Re: Turkey Point Unit 3  
Docket No. 50-250  
Response to Request for Additional Information Regarding the  
2007 Steam Generator Tube Inspection (TAC NO. MD9234)

**Response to NRC Request for Additional Information  
2007 Steam Generator Tube Inspections  
Turkey Point Nuclear Power Station, Unit 3  
Docket Number 50-250**

PHOTO 1 - SG 3A  
FLEX GASKET MATERIAL REMOVED

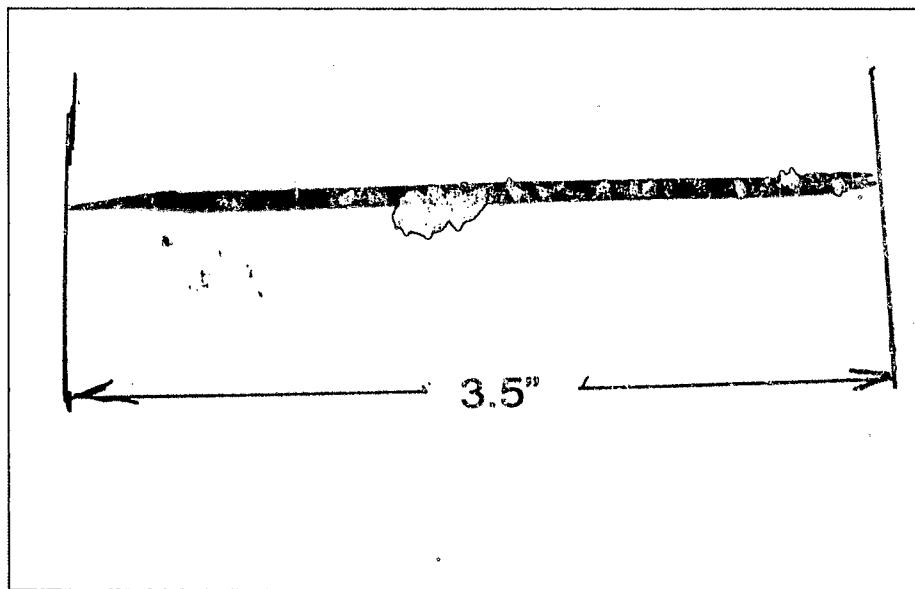
6. Please describe the scope and results of any secondary side inspections. If any degradation was detected, discuss the extent of the degradation and the basis for not inspecting the other SGs. Also, please discuss the results of the foreign object search and retrieval and secondary side upper bundle flush. Include in this discussion the extent to which the quatrefoil-shaped holes are blocked.

In addition to known objects from the prior outage, seven new objects were identified. Four of these objects were removed from the steam generators and are shown in the photos below. All objects remaining, or presumed to remain in the steam generators, are evaluated for adverse impact on steam generator operation and tracked during future inspections.

Visual inspection and foreign object search and retrieval (FOSAR) was conducted for the tubesheet region in all three SGs following upper bundle flushing and sludge lancing. These inspections were coordinated with primary side inspections to disposition potential loose parts detected by eddy current. No tube degradation was observed during the secondary side visual inspections.

Follow up inspections of known foreign objects determined that most were observed to be in the same locations as in the previous outage. Some of the objects observed during the previous

inspection were likely removed during sludge lancing and were not observed during the EOC 22 outage. When known foreign objects are not observed during two or more consecutive outages, the object is not actively tracked but the information is retained in the event it is observed in future inspections.
